# CPED STAFF REPORT

HPC Agenda Item #1  
 May 5, 2015  
 BZH-28634

*Property Location:* 400-404 3<sup>rd</sup> Avenue North  
*Project Name:* Scratch Restaurant Elevated Balcony  
*Prepared By:* [Shanna Sether](#), Senior City Planner, (612) 673-2307  
*Applicant:* Historic Crane Building  
*Project Contact:* Hellier Design, Bruce Hellier  
*Ward:* 3  
*Neighborhood:* North Loop Neighborhood Association, adjacent to Downtown Minneapolis Neighborhood Association  
*Request:* To allow for the construction of a new balcony and mechanical screening at the rear of the existing building.

<b>Certificate of Appropriateness</b>	To allow a new balcony and mechanical screening in the Warehouse Historic District.
---------------------------------------	---

1  
A2  
ELEVATION OF NEW DECK

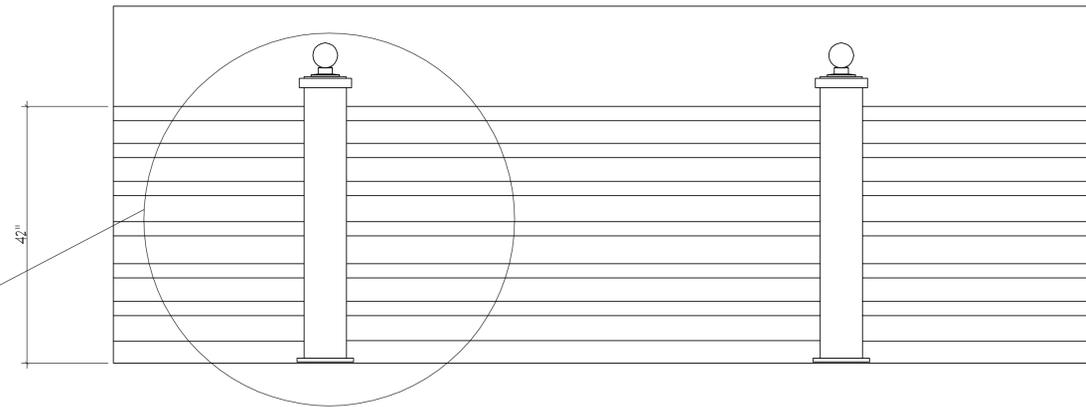
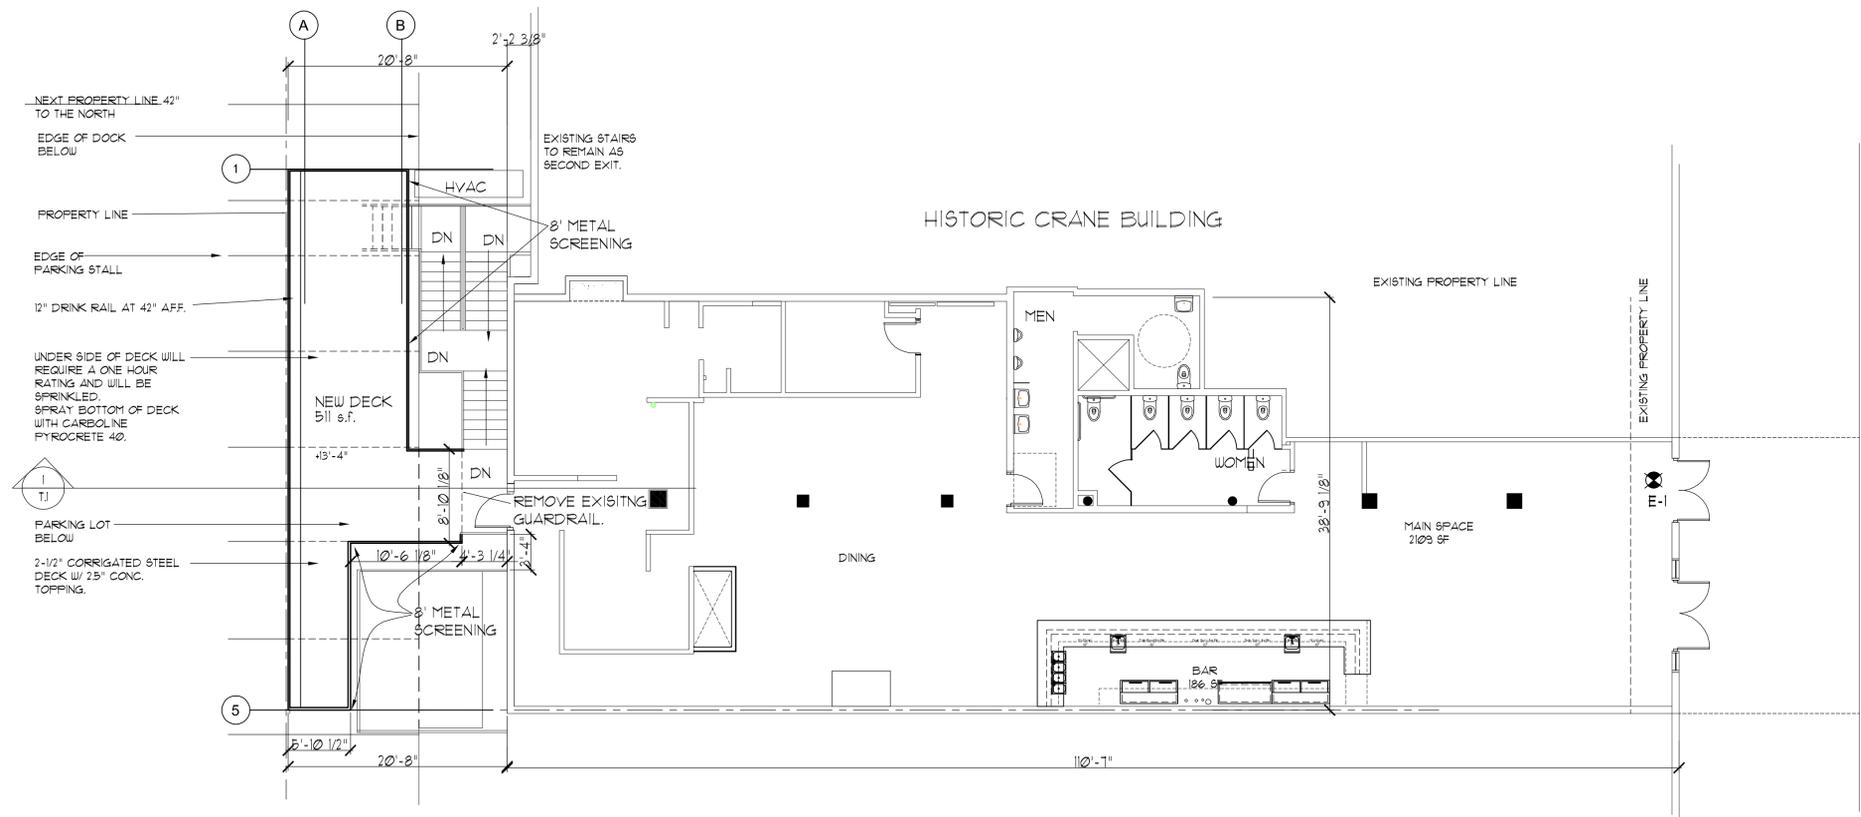
1. The balcony shall match in material and color to the existing egress landing and stairs and not create any new penetrations into the existing building.

2. The proposed mechanical screening shall be metal and not exceed 8 feet in height.
3. By ordinance, approvals are valid for a period of two years from the date of the decision unless required permits are obtained and the action approved is substantially begun and proceeds in a continuous basis toward completion. Upon written request and for good cause, the director may grant up to a one year extension if the request is made in writing no later than May 5, 2017.
